Fish Pass Advisory Service Sidmouth site visit

12th January 2023

Background

Figure 1 River Levels UK (Dec 2022- Jan 2023)¹

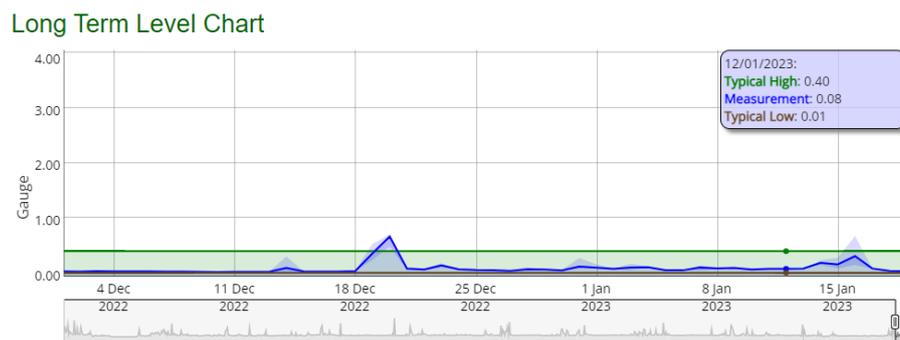
Despite recent high regional rainfall, the R. Sid did not appear to be running at a high level which aided the inspection of the structures in the area of interest. Historic river levels (Nov 2012 – Jan 2023) however, suggest that the level of 0.080m represents the level exceeded approximately only 15% of the time [measured at the ford crossing, EA gauging site ID 45216 (OS Grid: SY127876)] .

On the day of the site visit the fluvial flow is thought to be ~Q15 (see Figure 1) with a sufficiently deep route from the head of the beach through to the lower weir (tidal weir) close to the true right bank.

Figure 2 River Level exceedance (ID 45216)

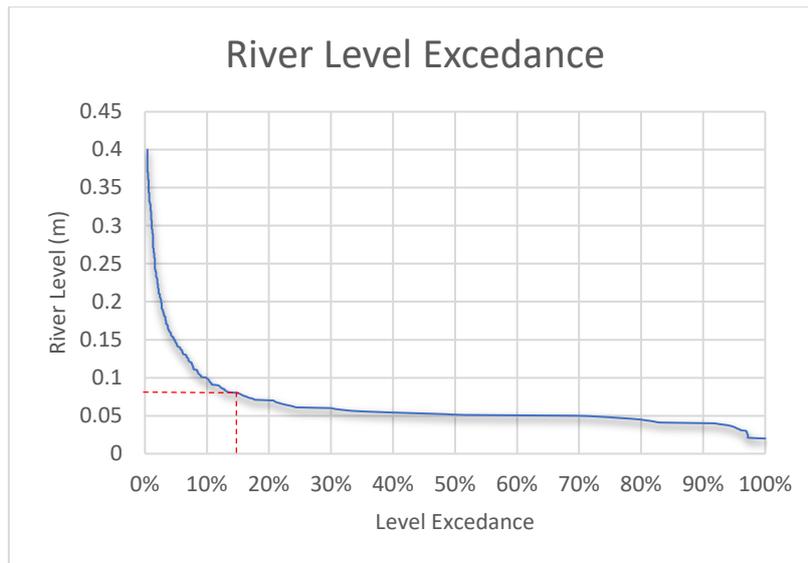
This finding indicates that the river level at the ford was within about 20mm of the level exceeded only 10% of the time which would be a normal upper expectation of flow or level for migratory salmonids to migrate. Interpolating the “Low Flows” flow duration curve provided by Fishtek (assumes no abstraction upstream) the Q15 flow should be of the order of $1\text{m}^3\text{s}^{-1}$ or about six times the Q95 flow that might normally be associated with the minimum for fish pass operation. Eels on the other hand would normally be expected to migrate at lower flows between $\sim\text{Q99}$ and Q70 .

Figure 10 Detailed water level exceedance curve (ID 45216)

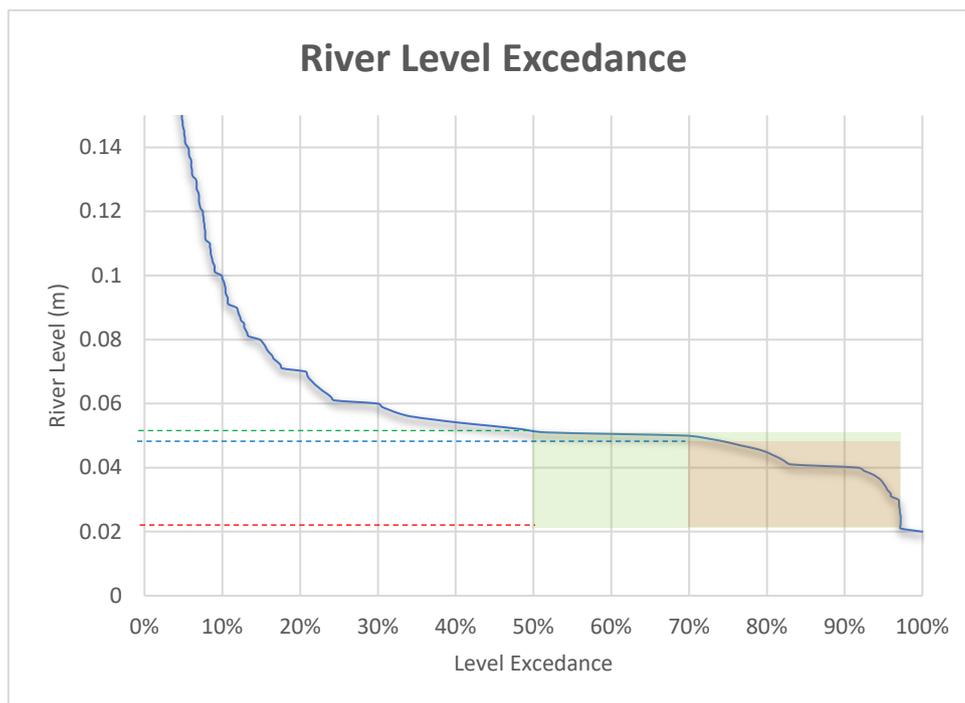
The curve above (Figure 8) shows more clearly that the change in water level at the Ford monitoring site from that exceeded 99% of the time to that exceeded 70% of the time is a difference of only ~30mm (orange area). Further to this, if the level exceedance is extended to 50% of the time (green

area) the level difference is still only ~32mm suggesting that measures to enhance eel passage could operate over a wider range of flows than the minimum guidance with virtually no extra costs of implementation relating to water level.

Figure 11 Ford weir aerial view

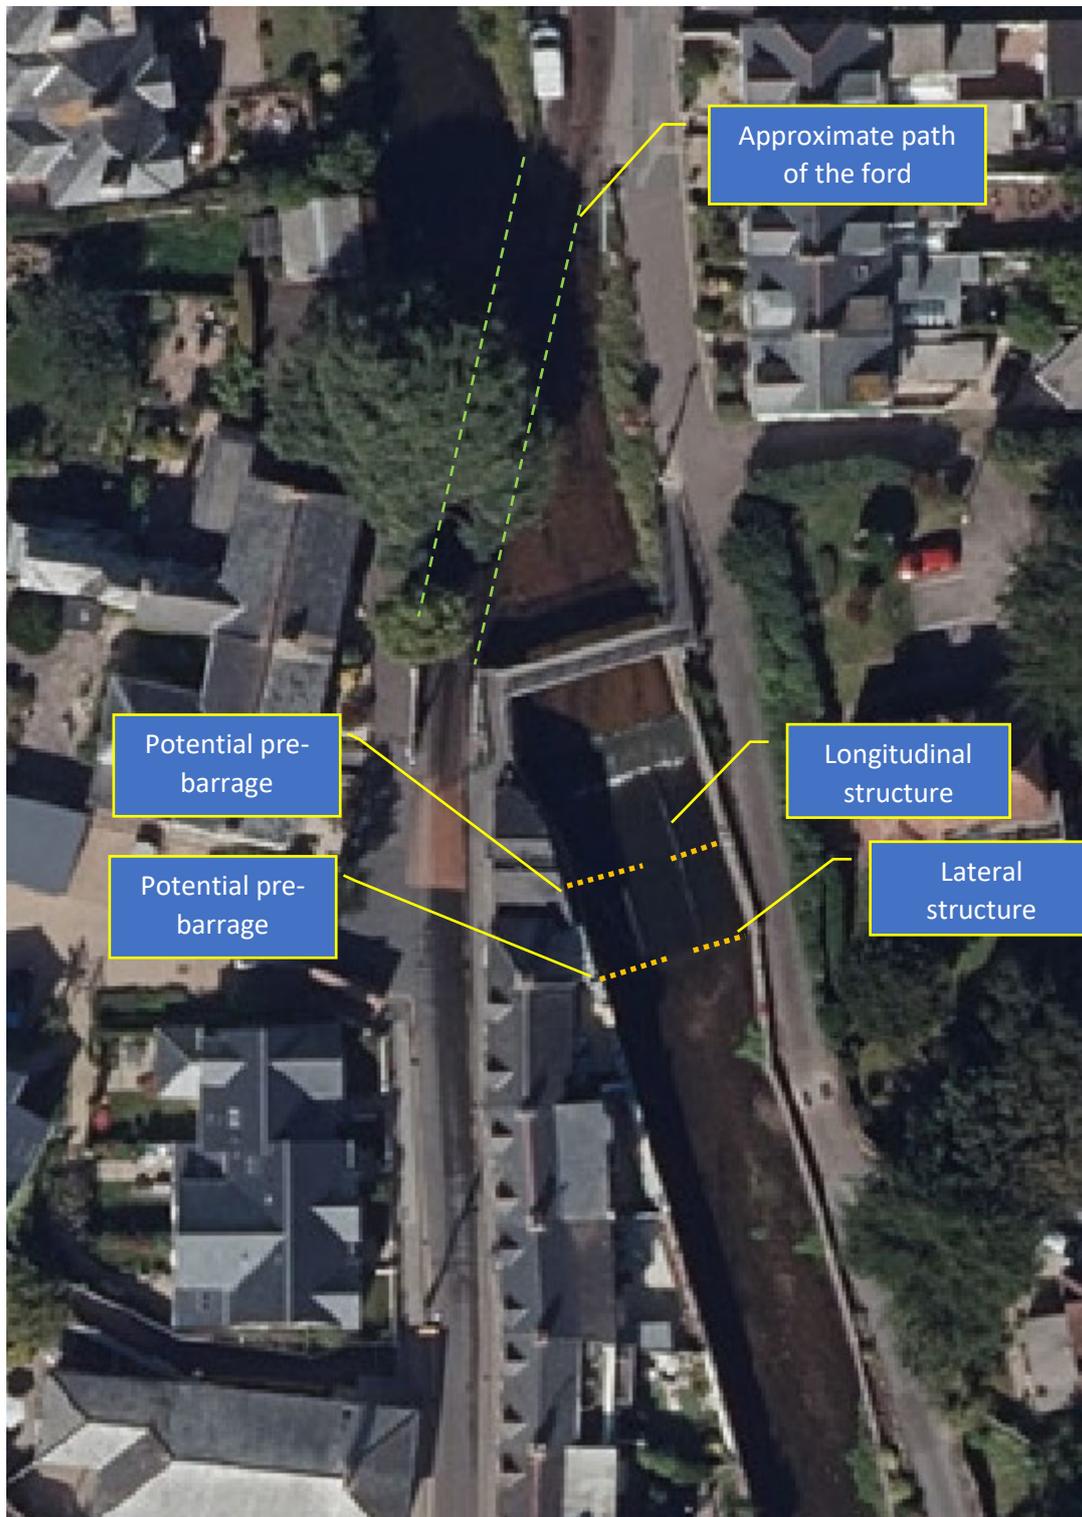
Downstream of the ford weir are both lateral and longitudinal structures that appear to occupy the extent of the anti-scour apron below the weir (see Figure 9). Migratory salmonids have been reported to accumulate below School Weir at high flows and so this demonstrates that the ford weir is passable at high flows. Measures to extend the flow range over which fish can surmount the ford weir should include a reduction of the head loss on the steep downstream face of the weir. Such mitigations may be possible by augmenting one of the lateral structures visible in the stilling basin (Figure 9, roughly indicated by the orange dashed line). The choice of positioning of the notch or gap could be influenced by the risk of erosion and the ease of maintenance. Normally the head loss associated with one pre-barrage fall would be limited to 0.45m and engineered to have an adherent nappe to limit air entrainment at the notch. It may be advisable to maintain sediment conveyance by designing a notch to extend to near the riverbed, but this will be dependent on the discharge range thought to be relevant to migratory fish access. The longitudinal structures may provide the

opportunity to reduce head loss further by introducing another pre-barrage between the weir and the lateral structure mentioned above. Breaks in the longitudinal structures would be needed if they are not drowned by the downstream pre-barrage to allow free access to the pre-barrage notch.

The second feature that challenges migratory salmonid fish passage is the presence of a relatively wide and shallow apron above the weir. The aerial view suggests that the longitudinal length of the upper apron is approximately 30m long and is extensively used as a vehicle ford when water depths allow. Ideally, the relatively flat apron might be modified to provide a slightly deeper longitudinal route for fish that has sufficiently gently sloping sides to maintain the operation of the ford. It may be that the ford could be normally closed when salmonids are migrating and so it may be possible to avoid any requirement to provide a deeper channel for fish on the upper apron. There is a clear requirement to identify when migratory salmonids are likely to be able to access this reach of the river.

Eel passage may be possible over the lower half of the flow range by simply augmenting the sloping weir to near the crest on each of the sides of the weir to provide a climbing surface for juvenile eel. This could be as simple as bonding suitable small pebbles to the sides of the weir face. Cleaning regimes should limit whole weir cleaning to ensure there is always a significant biofilm/algal surface to provide a more eel friendly surface for passage. The tops of these roughened areas should allow direct access to a low velocity path over the upper ford area even at low flows.
